Access Compliance Report

Public Rights-of-Way

(Curb Ramps)

Intersection ID: 49253	Main Street: LEGATO_LN	Cross Street: OAK_DR	Location: SW
ADA ID: 711007FC9BEA	Ramp Type: Perp	Initial Pass/Fail: Fail	Overall Compliance: No
Severity Score: 46.25			
Codes/Mitigation Info/Possible Solution		Field Measurements/Component Compliance

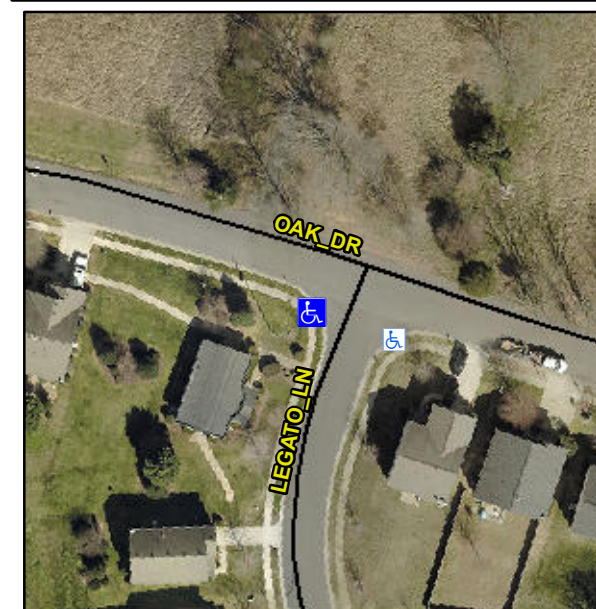
Not Found, R304.5.1, R304.2.2, R304.5.3

Compliance	Description	Data	Compliance	Description	Data
N/A	Ramp Length (in)	46.0	No	Ramp Slope (%)	10.5
No	Ramp Width (in)	42.5	No	Ramp XSlope (%)	8.1
N/A	Flare Type LT	N/A	N/A	Flare Type RT	N/A
N/A	Flare Slope LT (%)	N/A	N/A	Flare Slope RT (%)	N/A
N/A	Flare Traversable LT?	N/A	N/A	Flare Traversable RT?	N/A
N/A	Landing Length (in)	N/A	N/A	DWS Provided?	N/A
N/A	Landing Width (in)	N/A	N/A	DWS Contrast?	N/A
N/A	Landing Slope (%)	N/A	N/A	DWS Length (in)	N/A
N/A	Landing X Slope (%)	N/A	N/A	DWS Full Width?	N/A
N/A	Landing Curb? (Y/N)	N/A	N/A	DWS Offset (in)	N/A
N/A	Shared Landing?	N/A			
N/A	Gutter Ponding?	N/A	N/A	Gutter Slope (%)	N/A
N/A	Gutter Lip Ht (in)	2.0	N/A	Gutter X Slope (%)	N/A
N/A	Painted X Walk1?	No	N/A	Painted X Walk2?	N/A
	X Walk 1 Direction	To SE		X Walk 2 Direction	N/A
N/A	X Walk 1 Width (in)	N/A	N/A	X Walk 2 Width (in)	N/A
	X Walk 1 Slope (%)	0.4		X Walk 2 Slope (%)	N/A
	X Walk 1 X Slope (%)	9.3		X Walk 2 X Slope (%)	N/A

Remove & Replace Entire Ramp.
